ARCHITECTNICS, INC.
510 MAINE STREET
QUINCY, ILLINOIS 62301

ADDENDUM NO.: 2
ISSUED: 3/31/2021

Project: 2021 Capital Improvements
RALLS COUNTY R-II SCHOOL DISTRICT
21622 HIGHWAY 19
CENTER, MO 63436

This addendum becomes a part of the bidding and contract documents and modifies the drawings and specifications dated March 5, 2021. Acknowledge receipt of this addendum by noting such on the Contractor's Proposal (Bid) Form.

1 SITE PLAN
SCALE: 1" = 40'-0"

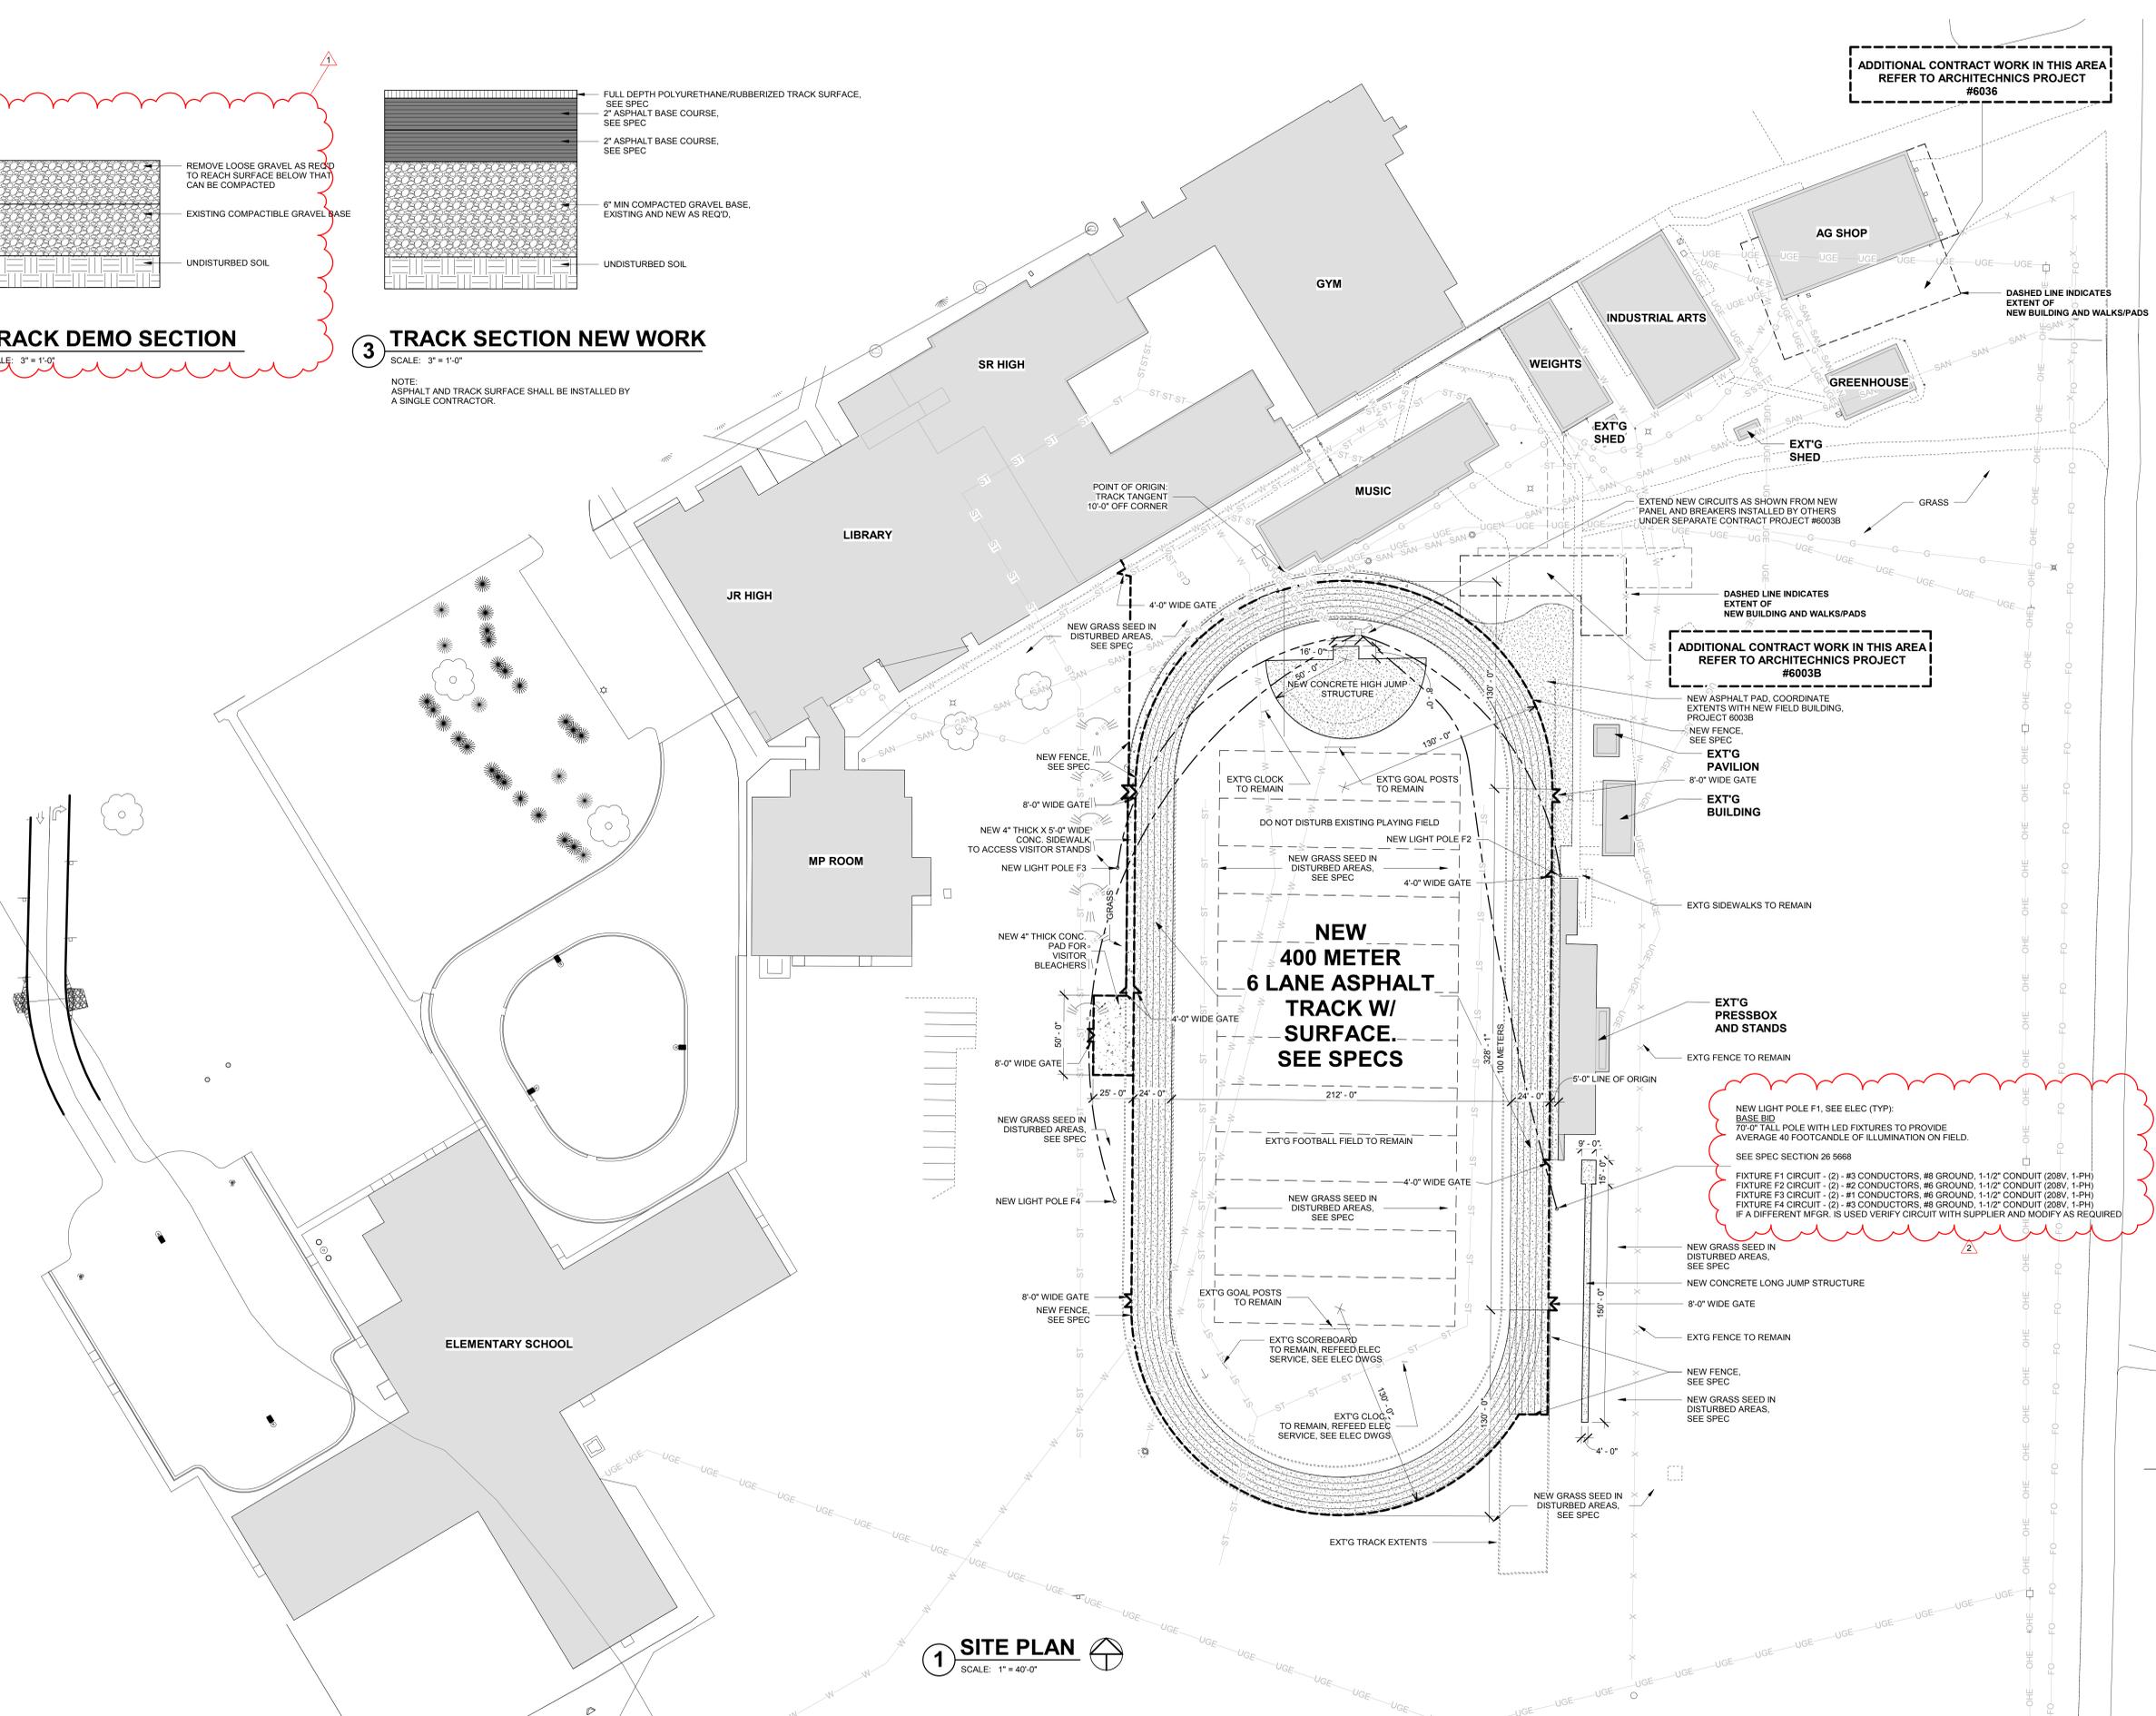
15.0	Sheet C101 Project 6003A	Replace	Replace with attached revised sheet. Added Field Lighting spec section. Revised circuit to Fixtures F2, and F3 to meet 3% voltage drop.
------	-----------------------------	---------	---

FIXTURE F1 CIRCUIT - (2) - #3 CONDUCTORS, #8 GROUND, 1-1/2" CONDUIT (208V, 1-PH)
FIXTURE F2 CIRCUIT - (2) - #2 CONDUCTORS, #6 GROUND, 1-1/2" CONDUIT (208V, 1-PH)
FIXTURE F3 CIRCUIT - (2) - #1 CONDUCTORS, #6 GROUND, 1-1/2" CONDUIT (208V, 1-PH)
FIXTURE F4 CIRCUIT - (2) - #3 CONDUCTORS, #8 GROUND, 1-1/2" CONDUIT (208V, 1-PH)
IF A DIFFERENT MFR. IS USED VERIFY CIRCUIT WITH SUPPLIER AND MODIFY AS REQUIRED

2 BEAM SCHEDULE

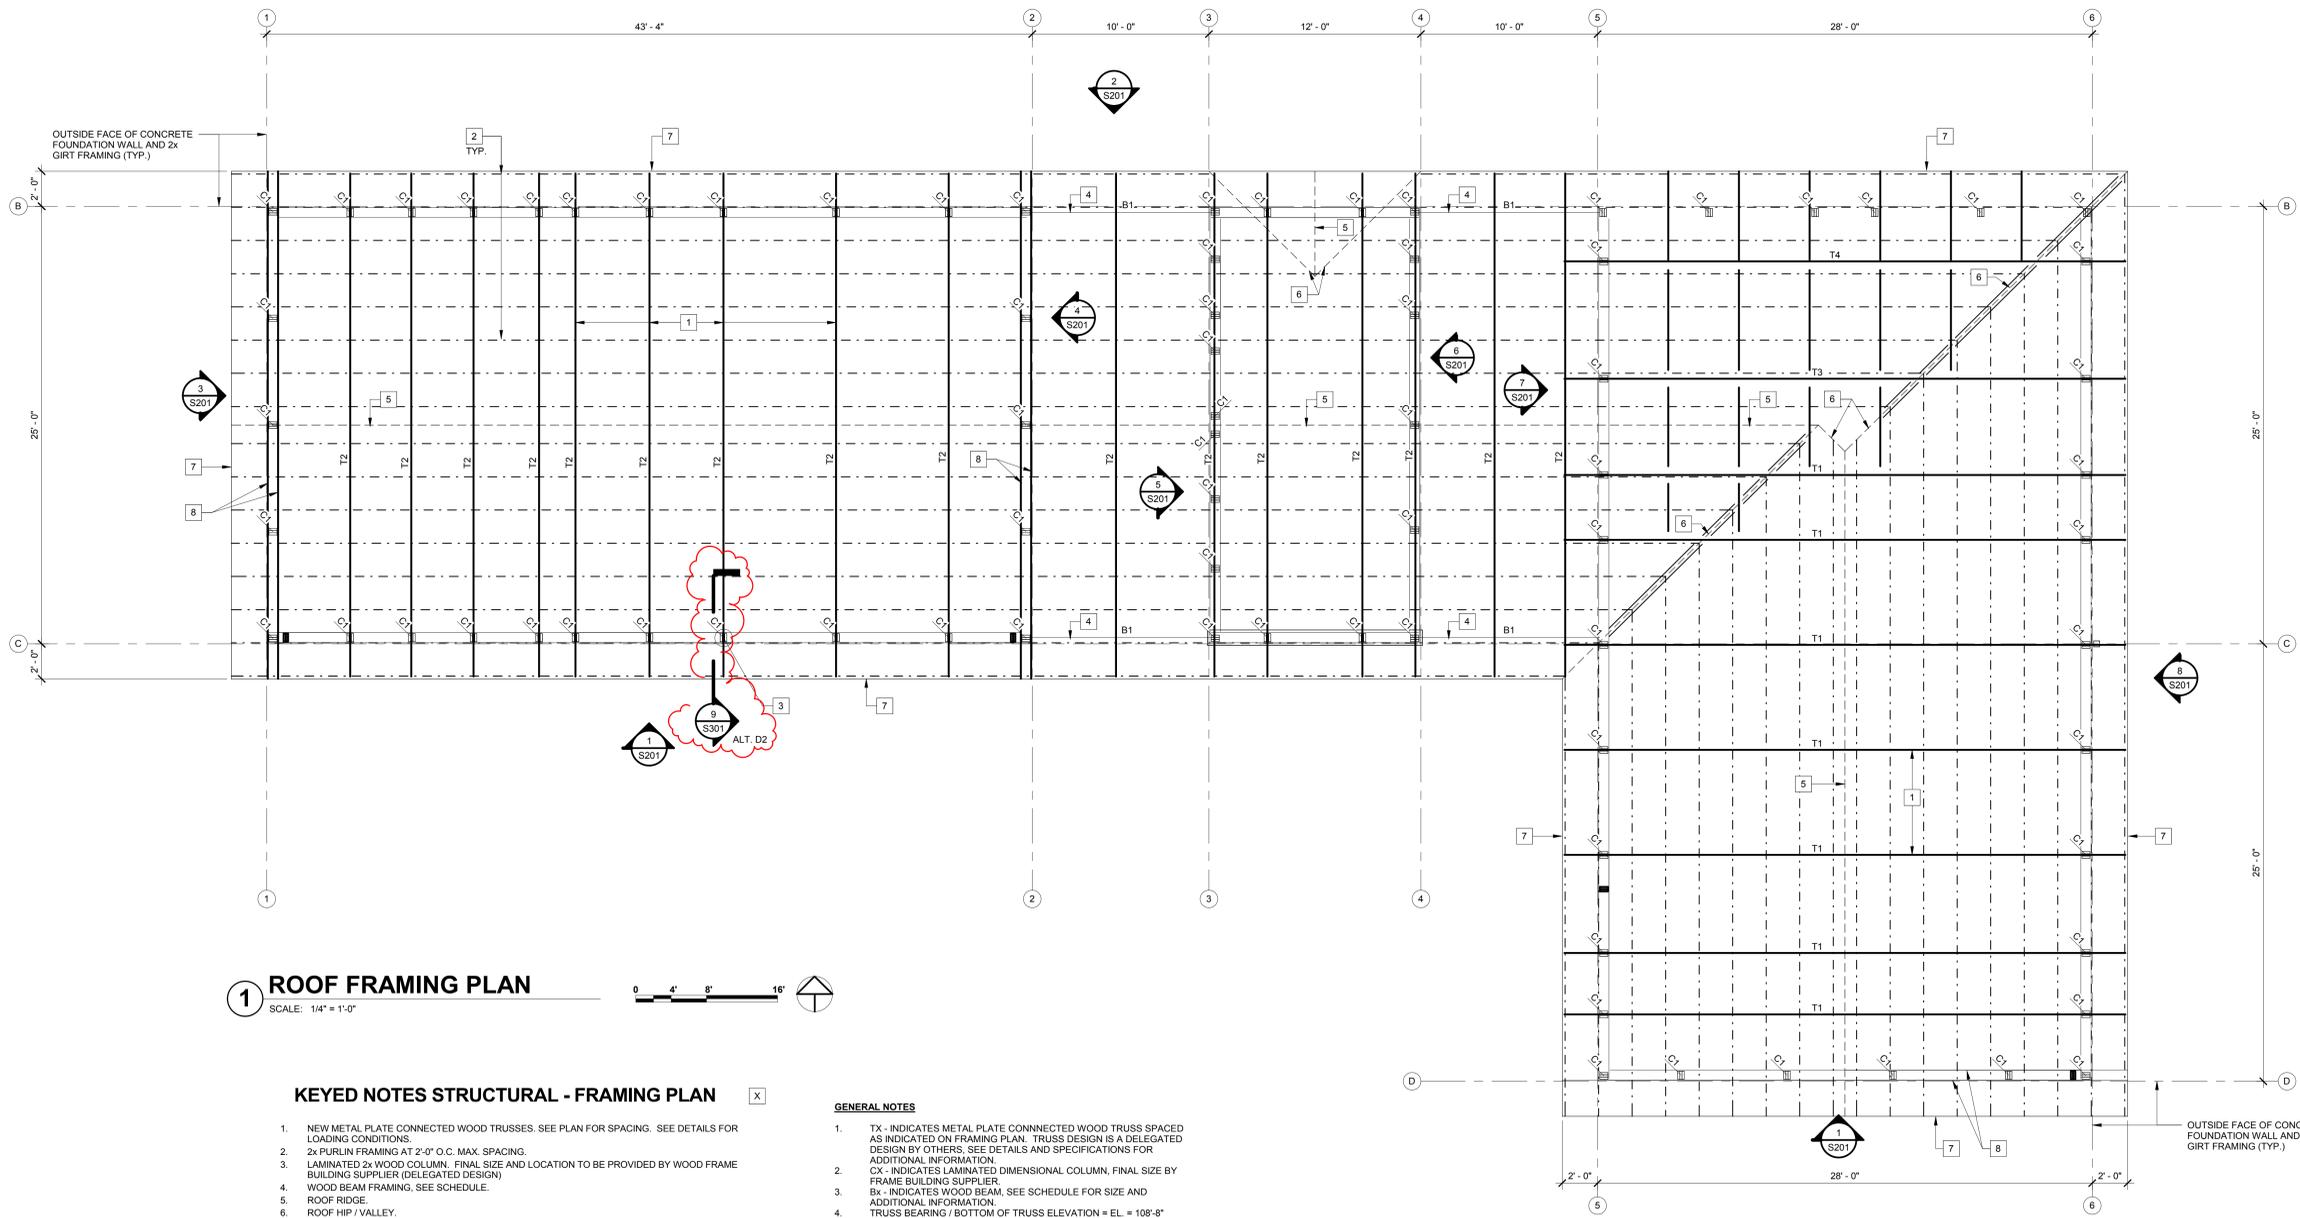
16.0	Sheet G000 Project 6003B	Replace	Replace with attached revised sheet. Wall Type B note revised.
17.0	Sheet S102 Project 6003B	Replace	Replace with attached revised sheet. Added beam schedule.
18.0	Sheet S301 Project 6003B	Replace	Replace with attached revised sheet. Gravel base clarified. Wall section detail revised.
19.0	Sheet A100 Project 6003B	Replace	Replace with attached revised sheet. Wall section detail revised. Added dimensions for toilet partitions, baby changing station and shower seat. Added fire extinguishers.
20.0	Sheet A101 Project 6003B	Replace	Replace with attached revised sheet. Wall section detail revised.
21.0	Sheet P200 Project 6003B	Add	PVC CL200 is approved for the water main piping.

MARK	MATERIAL	SIZE	END SUPPORT	BEARING LENGTH (MIN)	MECHANICAL CONNECTOR	REMARKS
B1	PSL 2.0E	3 1/2" x 9 1/4"	STUD WALL	3.5"	(3) TOE NAIL (EA END)	--

7 BEAM SCHEDULE
SCALE: 12" = 1'-0"

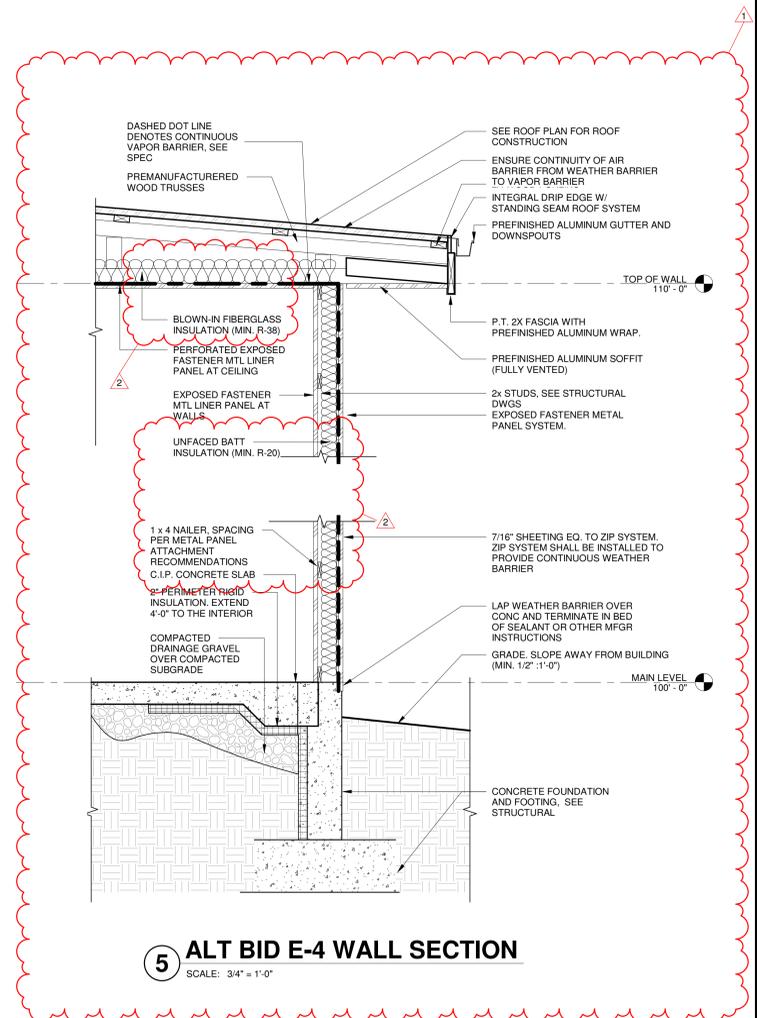
26.0	Sheet S401 Project 6036	Replace	Replace with attached revised sheet. Wall section detail revised. Added beam schedule.
27.0	Sheet A100 Project 6036	Replace	Replace with attached revised sheet. Wall section detail revised. Added fire extinguishers.
28.0	Sheet A200 Project 6036	Replace	Replace with attached revised sheet. OH door size and notes revised. Wall section detail revised.

MARK	MATERIAL	SIZE	SUPPORT	BEARING LENGTH (MIN)	MECHANICAL CONNECTOR	REMARKS
B1	PSL 2.0E	3 1/2" x 9 1/4"	EXISTING LAMINATED WOOD COLUMN @ 6'-0" V.I.F.	3.5"	ANGLE BRACKET SEE DETAIL XXX	BEAM IS CONTINUOUS, COORDINATE FIELD SPLICE LOCATIONS
B2	SP NO. 2 OR BETTER	(2) 2x10	EXISTING LAMINATED WOOD COLUMN @ 6'-0" V.I.F.	--	(2) 3/4" A307 THRU-BOLT @ EACH COLUMN	BEAM IS CONTINUOUS, COORDINATE FIELD SPLICE LOCATIONS; BEAM SLOPES WITH ROOF 1:12
B3	PSL 2.0E	3 1/2" x 11 1/4"	STUD WALL	3.5"	(3) 10d TOE NAIL	--
B4	PSL 2.0E *	(2) 3 1/2 x 16"	PSL COLUMN	5.5"	STEEL COLUMN CAP	--
B5	SP NO. 2 OR BETTER *	(2) 2x10	--	--	(2) 3/4" A307 THRU-BOLT @ EACH COLUMN	BEAM IS CONTINUOUS, COORDINATE FIELD SPLICE LOCATIONS.
B6	SP NO. 2 OR BETTER *	2x8 @ 16" O.C.	B4 & B5	1.5"	LRU28Z	FACE FASTENERS: (8) 10d x 1.5 JOIST FASTENERS: (8) 10d
